FAA Response to SFO Roundtable

April 3, 2019

Federal Aviation
Administration

(OFFSH1.MCKEY) 17341
OFFSHORE ONE DEPARTURE AL-375 (FAA) SAN FRANCISCO INTL (SFO)
 SAN FRANCISCO, CALIFORNIA

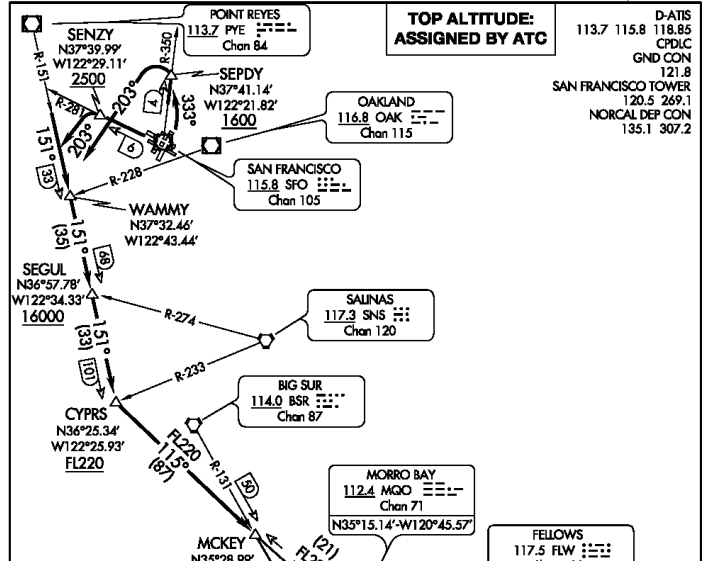
- What would be required to achieve converting the OFFSHORE DP into an RNAV DP and
 - 1) Change the angle to stay over the Pacific Ocean and not over or near the Peninsula
 - 2) Repeat to the extent possible the geographical path of the OFFSHORE from takeoff to the Pacific Ocean
 - 3) Connect at FFOIL or another similar offshore waypoint while remaining clear of Special Use Airspace (SUA)?
- If the OFFSHORE DP cannot be turned into a RNAV with the above considerations, can a DP be constructed that achieves the same basic ground track as the existing OFFSHORE DP with the above considerations?

Item 3 – SSTIK

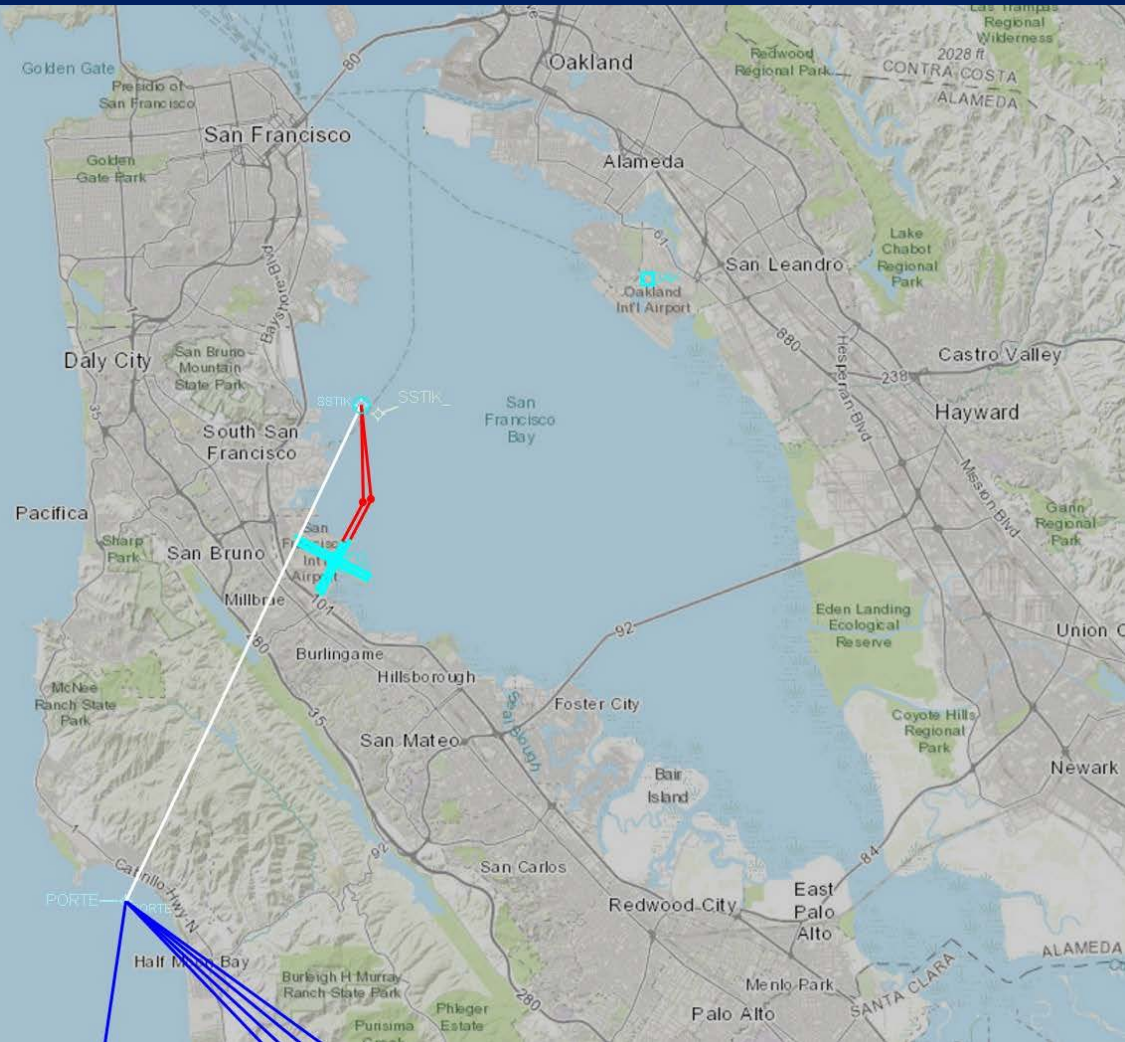
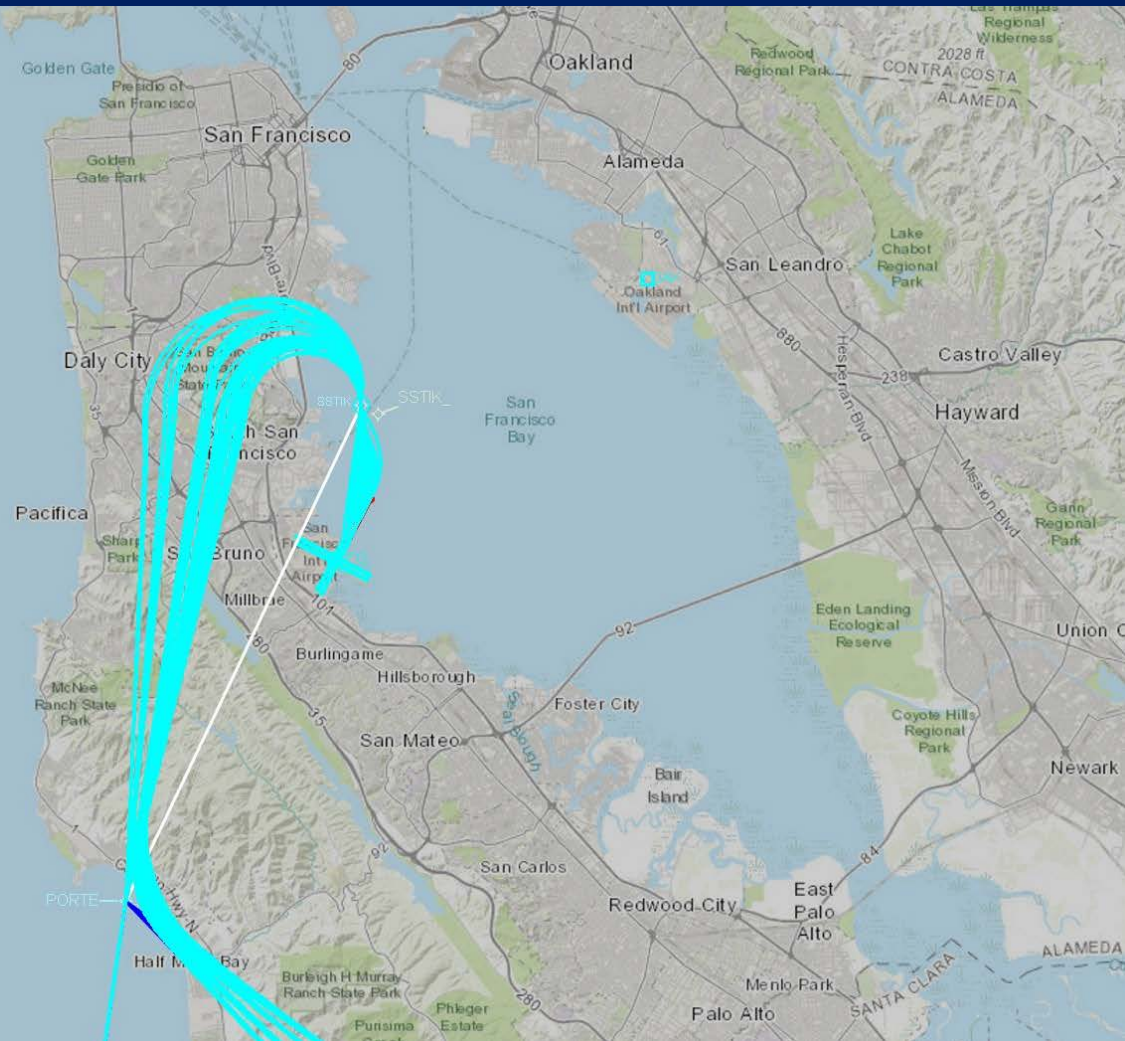
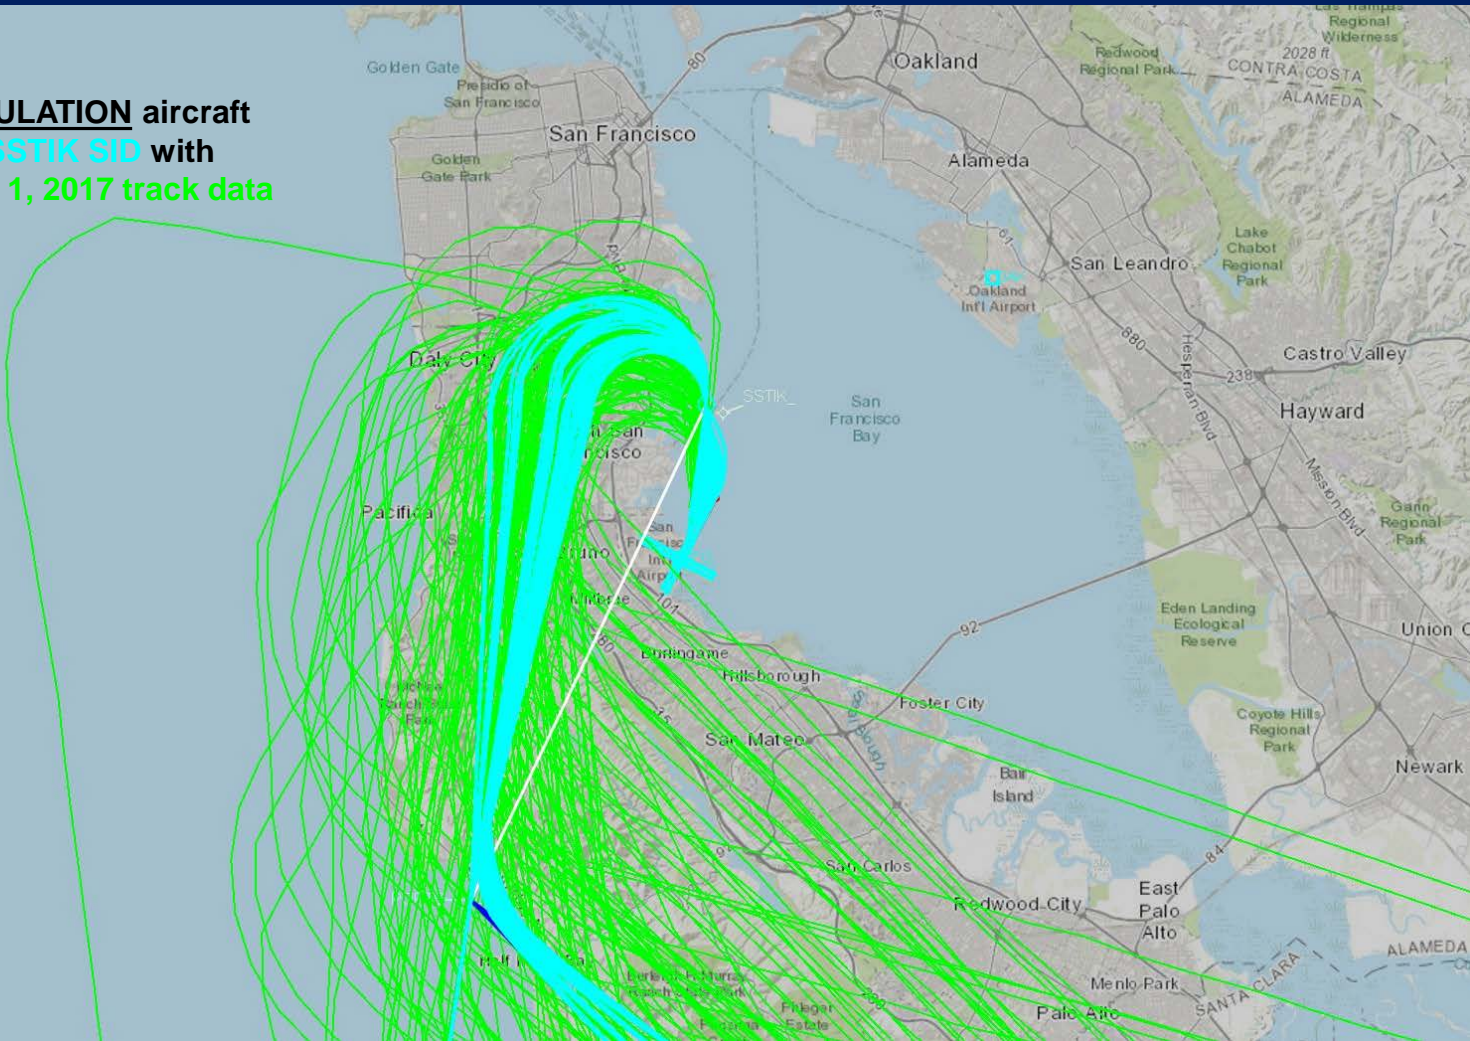
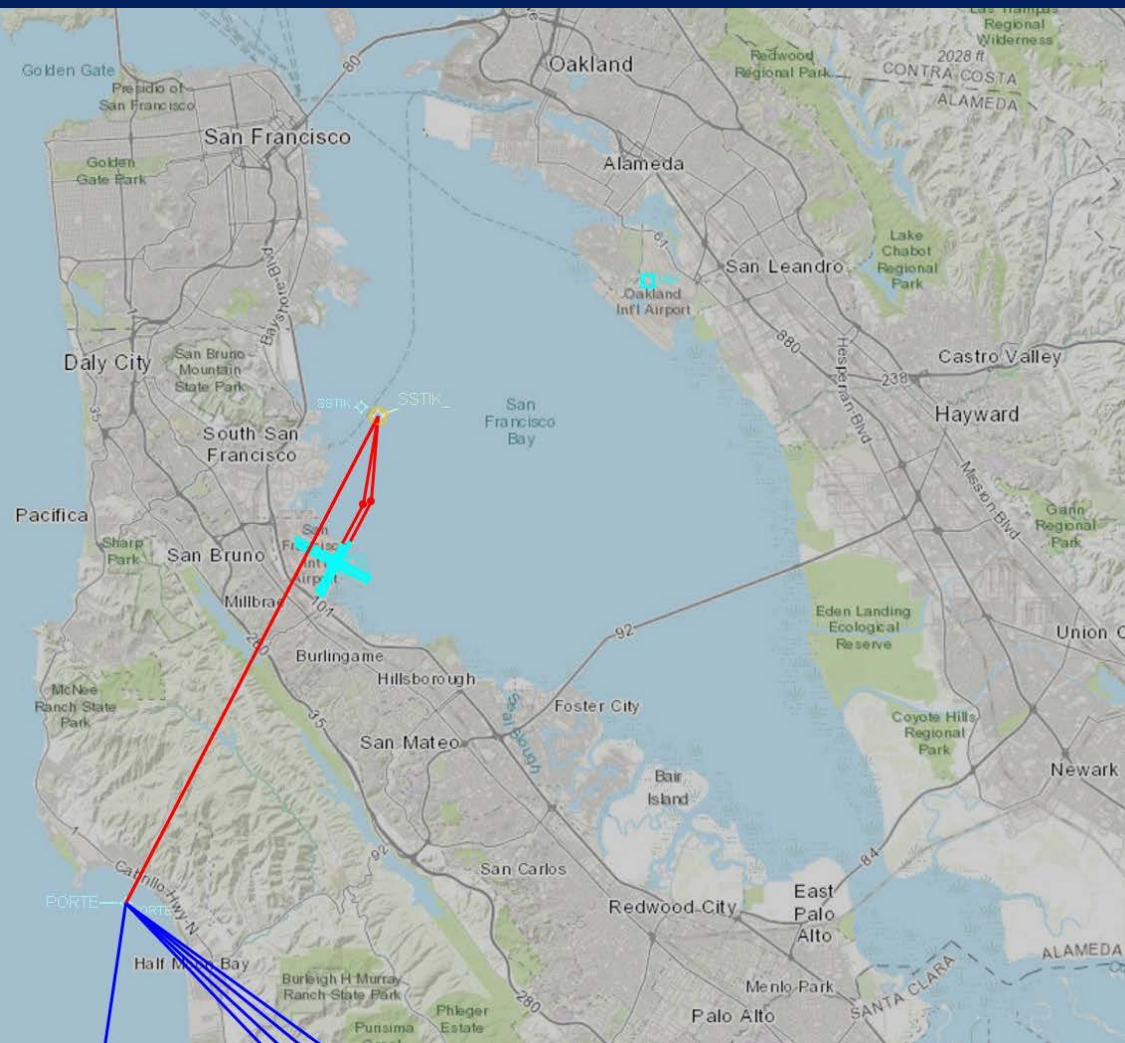
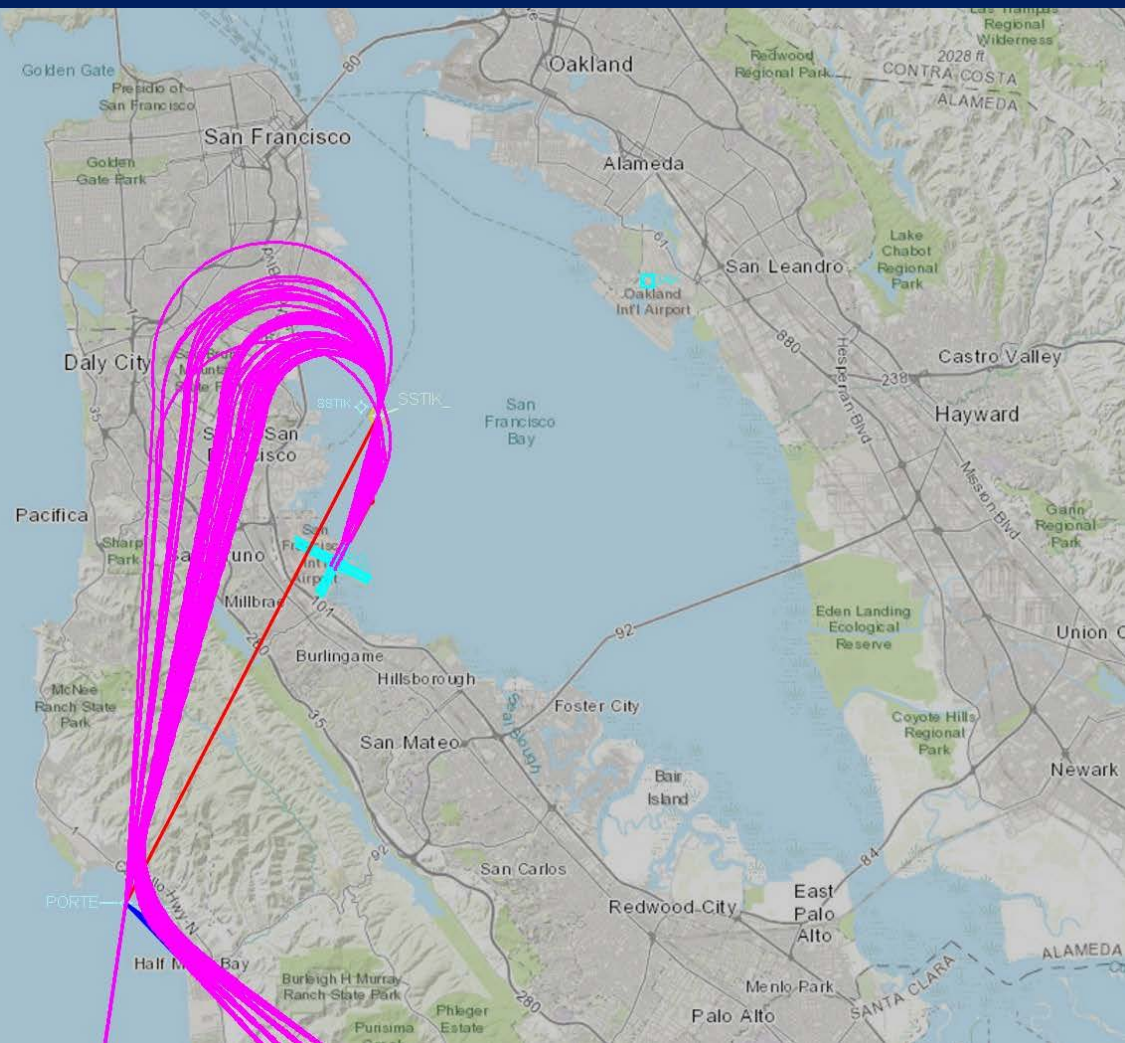
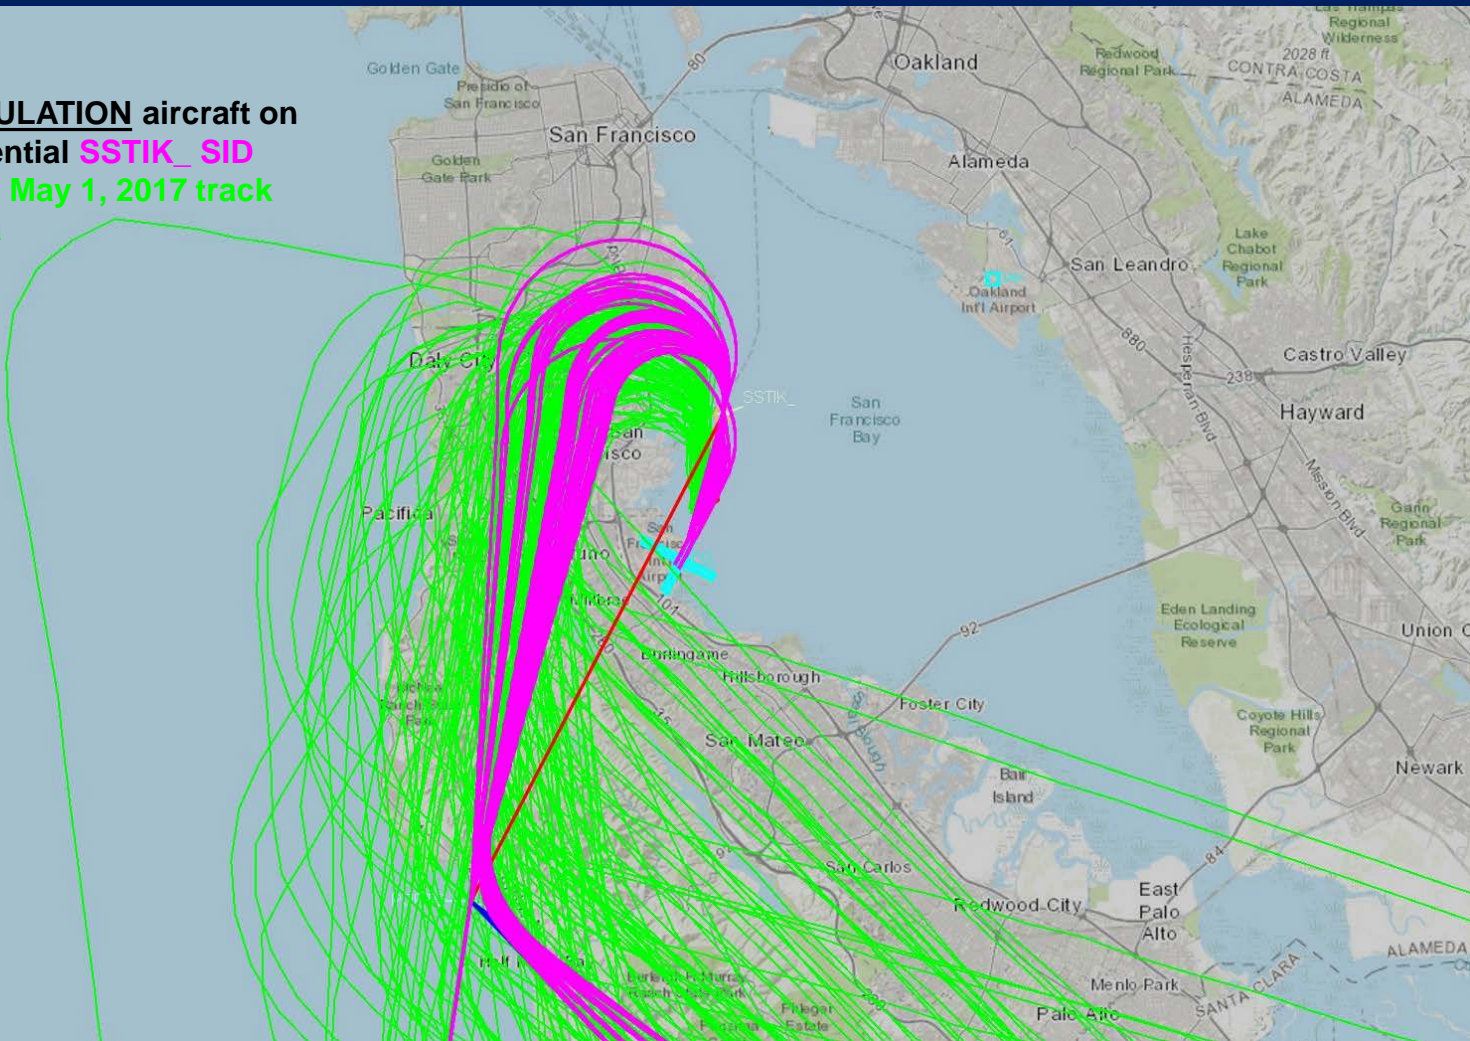
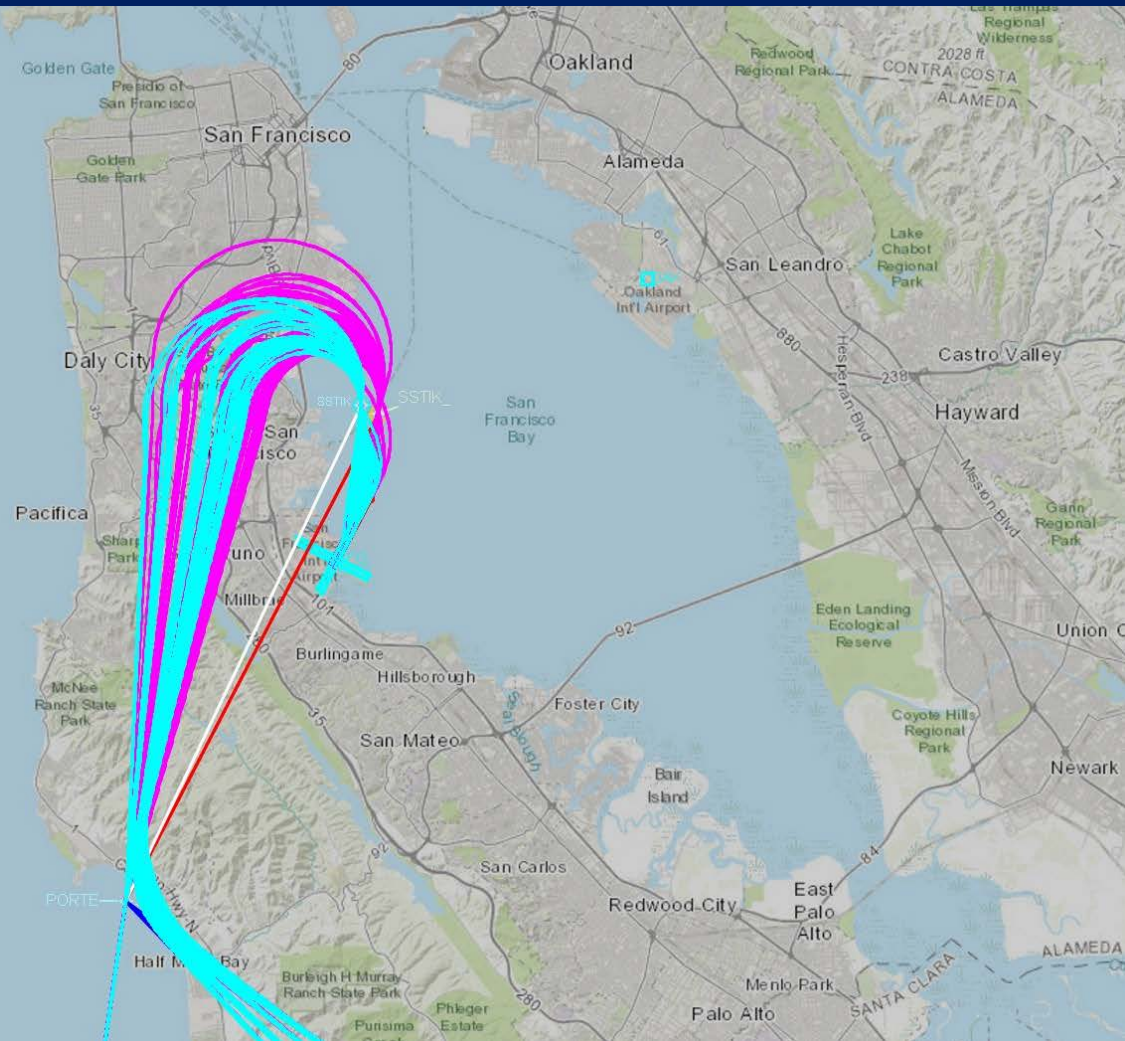
- Current Questions
 - Why is it being shelved?
 - What is the reasoning behind not being able to answer the previously submitted questions regarding this item?
- Previously Submitted Questions
 - Can the FAA overlay the proposed new SSTIK waypoint with the current SSTIK waypoint in the same image and provide both current and proposed SSTIK DPs in Google Earth KML files?
 - This will include the ground track for the procedure as it is today as well as the procedure as it would look with the new SSTIK waypoint. We request modeled flight track information for these two waypoints on the SSTIK procedure as well as the new charting date.
 - Please provide the design notes for the change in the SSTIK waypoint location.

Proposed SSTIK
waypoint move to
the ESE 0.44nm
